Lynn Lake Gold Project: MacLellan Mine Plan Amendment Notice of Alteration / Notice of Change

Federal Information Request Responses

July 31, 2025

Prepared by:
Stantec Consulting Ltd.

Figure NOC IR-17 Measured and Modelled Site Unit Streamflows during Concurrent Period of Record with Regional Hydrometric Station (WSC05TF002)

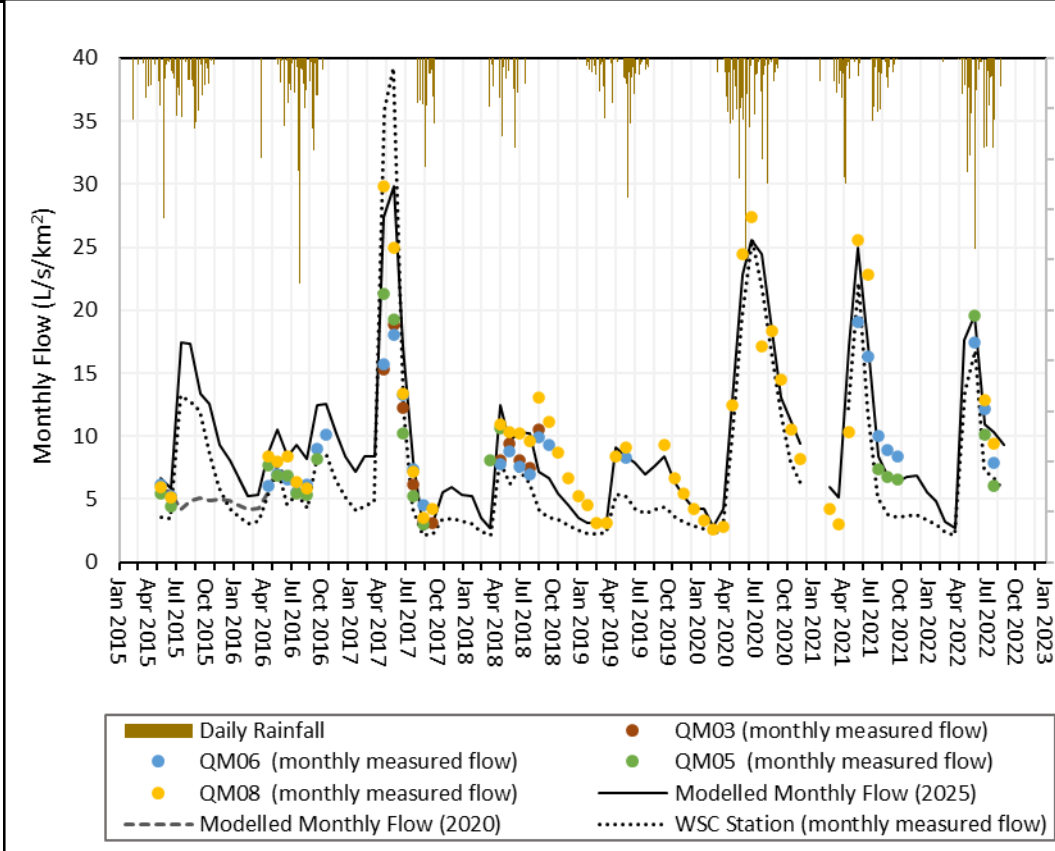
ID:	NOC IR-17
Topic	Water Quantity, Fish and Fish Habitat and Aquatic Species
Expert Department or Group:	ECCC
NOA/NOC reference:	Section 3.3.4 Appendix F
Information Request:	<p>Context/Rationale:</p> <p>Regarding water quantity, the Notice of Alteration does not provide sufficient information to comment on the adequacy of the Proponent’s analysis and conclusions of the effects related to the proposed Project changes.</p> <p>Initial observations made from the information presented in the Notice of Alteration include the following:</p> <ul style="list-style-type: none"> •The Proponent notes that the freshwater intake and effluent discharge locations have been moved upstream from node QM03 to QM02 (Appendix F; Section 2.1.2). However, no further discussion on how this change affects water management has been provided. •The Proponent states that the water balance method used for estimating receiving environment streamflow was improved (Appendix F; Section 2.2). However, the changes in methodology and the validation parameters were not compared to those included in the original EIS. The updated receiving environment methodology was only validated against one hydrometric station with the largest drainage area (QM08; Appendix F, Figure 2.7), without assessing the accuracy at other smaller nodes within the receiving environment. •There is insufficient information on the methodology and accuracy of water level predictions for key lakes, including Minton Lake and Cockerham Lake. Additionally, potential impacts on upstream and downstream water levels were not directly evaluated at all nodes nearest to key lakes, such as Dot Lake and Payne Lake. <p>Request for Additional Information:</p> <p>Provide additional technical documentation and a detailed discussion to substantiate the potential effects on water quantity resulting from the proposed Project changes. This may include (non-inclusive): a description of water management structures including an evaluation of potential changes to water quantity at the intake and discharge points; detailed discussion of any updated methodologies including a description of how potential changes to water levels in lakes are evaluated; a comparison of revised model performance metrics comparing the statistical parameters with those presented in the EIS; an evaluation of the water balance model performance at hydrometric stations to</p>

ID:	NOC IR-17
	better demonstrate adequate hydrological characterization throughout the receiving environment; and an assessment of changes in lake water levels resulting from the proposed Project changes for Dot Lake and Payne Lake.

Response:	<p>The description of water management structures (e.g., the freshwater intake and effluent discharge) is provided in Sections 18.3.4, 18.3.6, 18.3.8, 18.3.9, 18.3.10, 18.3.11, and 18.3.14 of the 2023 Feasibility Study Update NI 43-101 Technical Report (Abols et. al, 2023). As shown on the conceptual flow diagram (Figure 2.2 in Appendix F of the 2025 MacLellan Mine Plan Amendment MacLellan NOA/NOC; Stantec 2025), flow predictions for the freshwater intake and effluent discharge have been included in the water balance model. Predicted flow rates at QM02 (Table 2.6 in Appendix F of the 2025 MacLellan Mine Plan Amendment MacLellan NOA/NOC; Stantec 2025) represent the potential effects of freshwater intake and effluent discharge on water quantity at the intake and discharge point (i.e., at QM02).</p> <p>Figure NOC IR-17 (below) shows that the calibration/validation of the 2020 model (Stantec 2020) was based on less than 10 months of measured data during 2015-2016. Measured data during that period missed the high flows in late-summer and fall of 2015 that were driven by prolonged rainfall events (the signature of which is apparent in measured streamflows in the nearby Water Survey of Canada station (WSC05TF002). Although the 2020 modelled flows missed these high flows, numerical validation parameters (e.g., Nash-Sutcliffe Efficiency) were artificially very high because these numerical validation parameters only consider the months with measured data and may lead to misleading conclusions regarding the reliability of model results (Naghbi and Luzi 2022). Reliance on numerical validation parameters would be even less relevant if different models simulate different periods (e.g., the 2020 model simulating one year vs. the 2025 model simulating seven years). Instead, a visual comparison of unit area flow model results shows that the 2025 model outperforms the 2020 model (Figure NOC IR-17).</p> <p>Similarly, although the other hydrometric stations have a shorter period of measured monthly streamflows (compared to QM08), the visual comparison of measured and modelled unit area streamflows shows an acceptable match for the stations (Figure NOC IR-17).</p>

Attachment 9-1 (Map)

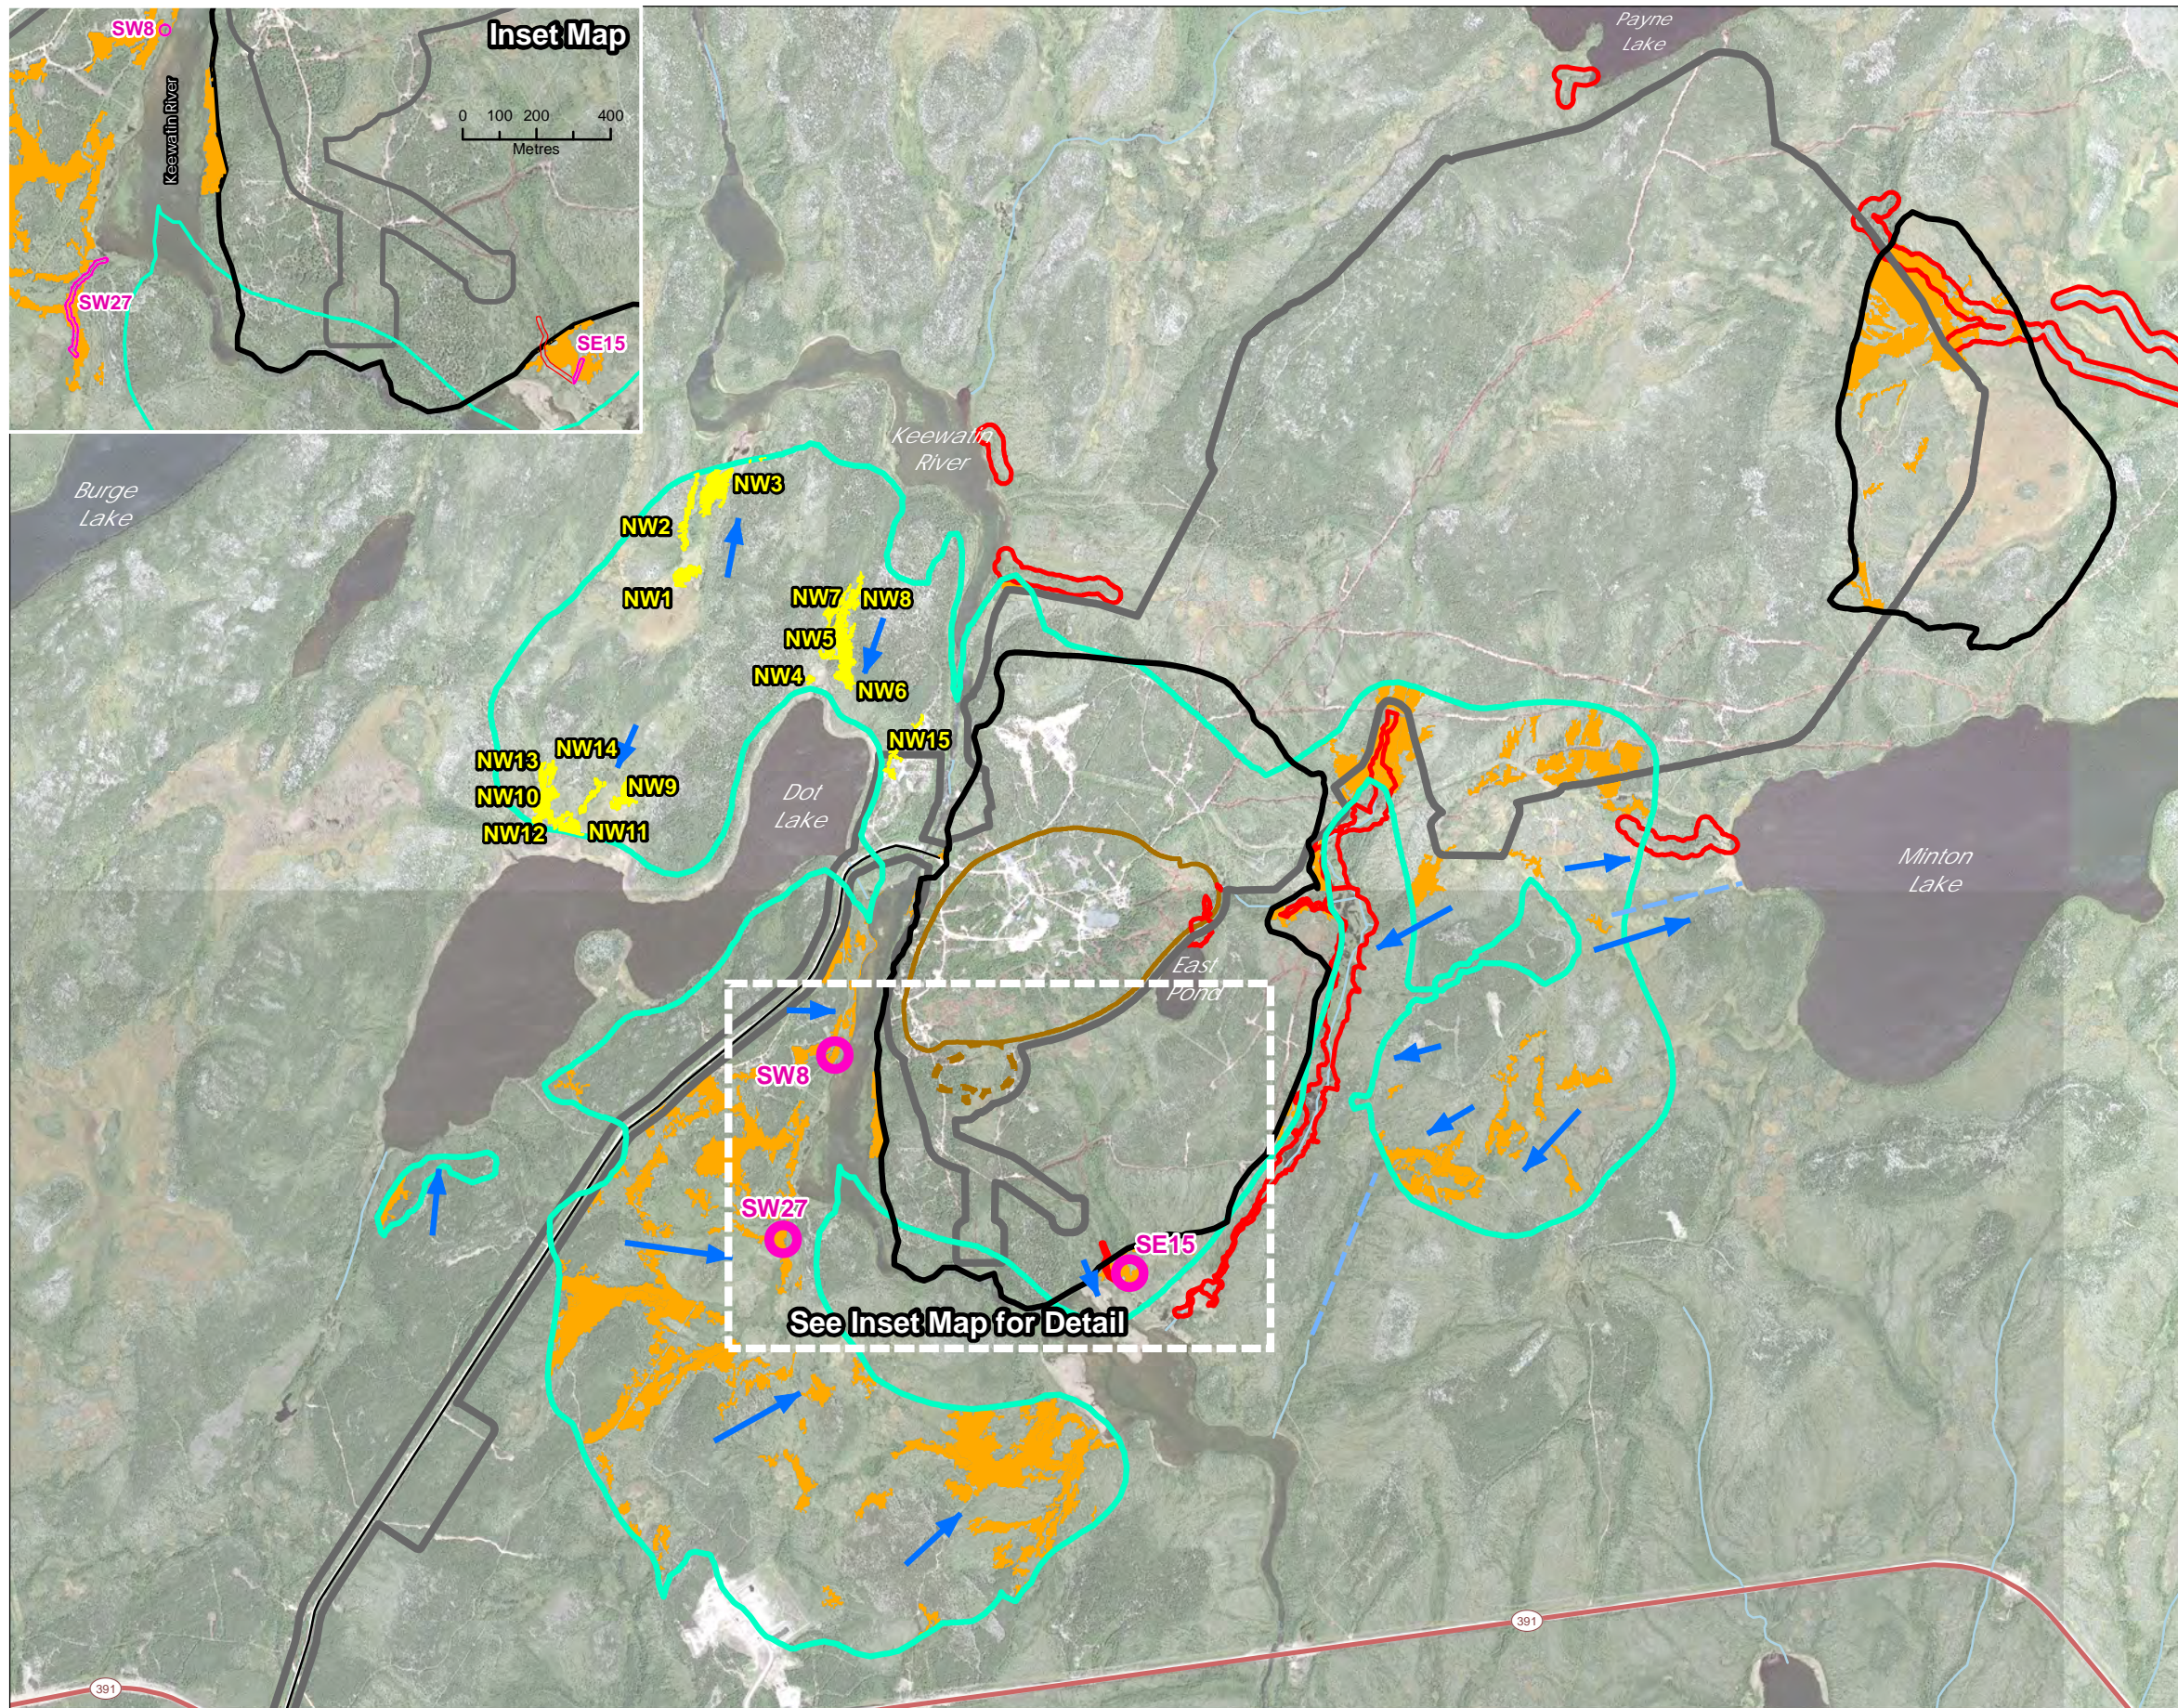
ID:	NOC IR-9
Topic	Groundwater Drawdown, Fish and Fish Habitat and possibly Aquatic Species
Expert Department or Group:	ECCC DFO
NOA/NOC reference:	Section 3.3.5 Appendix A - Map 5
Information Request:	<p>Context/Rationale:</p> <p>The Proponent states that:</p> <p>“Compared with the results of the EIS (Stantec 2020e), the effects of the Project on groundwater remained similar, except for the extent of the drawdown cone which was larger in this model iteration.”</p> <p>“A final dewatering head of approximately -60 m amsl will result in the drawdown of the water table by up to 1 m over an area extending approximately 1 km north, 1 km east, 2 km south, and 2 km west of the pits. The maximum drawdown in the deepest portion of the pit is nearly 400 m. Drawdown from the MRSA extends approximately 500 m east of the MRSA. Mounding due to the TMF extends approximately 1 km west and reaches a maximum greater than 26 m.”</p> <p>As groundwater generally feeds wetlands, the increased drawdown could cause the drainage of wetlands and effects on fish and fish habitat. See Map no. 5 from the Notice of Alteration for wetlands affected by drawdown greater than 1m, which encompasses wetlands within the drawdown zone.</p> <p>The Proponent has not provided information to characterize the wetlands that are now anticipated to be impacted by groundwater drawdown, including whether they are groundwater or surface water dominated, and whether they are fish bearing (see ECCC comment #3).</p> <p>Without this information, it is difficult to understand the updated extent of effects on fish and fish habitat.</p> <p>Request for Additional Information:</p> <ol style="list-style-type: none"> a) Clarify whether the wetlands are fed by groundwater or surface water, and to what extent. Provide supporting technical information to substantiate the expected level of wetland drainage. b) Provide additional information on the consequences of lowering the water table by 1m on wetlands and the effects to fish and fish habitat. The Proponent should detail the extent to which wetlands will be reduced or disappear.

ID:	NOC IR-9
	<p>c) Provide an update on your ongoing assessment of fish-bearing status of wetlands.</p> <p>Flag from DFO: DFO advises that fish sampling to determine fish presence or absence typically requires that efforts are repeated in multiple years and multiple seasons.</p>
<p>Response:</p>	<p>a) For the purposes of its assessment of potential effects of predicted groundwater drawdown on fish-bearing wetlands, Alamos has assumed that wetlands at the MacLellan site are groundwater-fed. This is a conservative assumption because groundwater table depth is variable near the MacLellan site and in many areas, groundwater table depth may be too deep to interact with surface water levels. Groundwater and surface water level monitoring as part of the GWMMP and SWMMP, respectively, will be used to refine the characterization of the groundwater-surface water interaction in wetlands as the Project progresses. However, new future information about groundwater-surface water interactions will not alter how Alamos will quantify the potential harmful alteration, disruption, or destruction (HADD) of fish-bearing wetlands at the MacLellan site for inclusion in the <i>Fisheries Act</i> authorization.</p> <p>b) Like the EIS, Alamos assumes that confirmed fish-bearing swamps within the updated zone of predicted groundwater table drawdown at the MacLellan site will be dewatered during mining operations and, therefore, will result in a HADD of fish habitat. This is a conservative assumption because of the uncertainty about the groundwater contribution to fish-bearing swamps at the Gordon and MacLellan sites. Alamos started to confirm the presence of fish-bearing swamps within the updated zone of predicted groundwater drawdown at the MacLellan site in spring 2025 and will continue this effort in August 2025, wildfire conditions permitting. Positively confirmed fish-bearing swamps within this updated zone will be added to the total HADD of fish habitat reported in the <i>Fisheries Act</i> Authorization application. Gain-to-loss ratios will be updated using the relative habitat value system described in the <i>Fisheries Act</i> Authorization application and the need for additional offsetting will be discussed with DFO, if required.</p> <p>c) Map 5 in Appendix A of the NOA/NOC application identifies the remotely sensed treed and shrubby swamps within the updated zone of predicted groundwater table drawdown at the MacLellan site. Alamos began ground-truthing these remotely sensed swamps in spring 2025 and was able to visit the identified swamps except those north of Dot Lake before wildfires caused the evacuation of Lynn Lake. At each location, field crews recorded the presence or absence of water and evidence of downstream connectivity to known fish-bearing watercourse or waterbody. Photographs of each site were also taken. Of the 69 remotely sensed swamps that were visited in spring, only three were positively identified as having water and surface connectivity to a fish-bearing watercourse or waterbody (SW8, SW27, and SW15; see Attachment 9-1 [map] in Appendix A). Alamos plans to revisit these three swamps and to visit the remotely sensed swamps north of Dot Lake this August 2025 (wildfire conditions permitting).</p>

ID:	NOC IR-9
	<p>Note that none of the remotely sensed swamps north of Minton Lake were visited in spring 2025. This is because the geographic extent of fish-bearing habitat in the headwaters of Minton Lake, including potential fish-bearing swamps, were determined during multi-season sampling in 2019 (fall) and 2020 (spring and summer). The footprint of the Mine Rock Storage Area was adjusted after these surveys specifically to avoid impacting fish-bearing habitat with the deposit of deleterious mine rock that would have triggered amendment of Schedule 2 of the Metal and Diamond Mine Effluent Regulation.</p>
Attachment	Yes – see Appendix A.
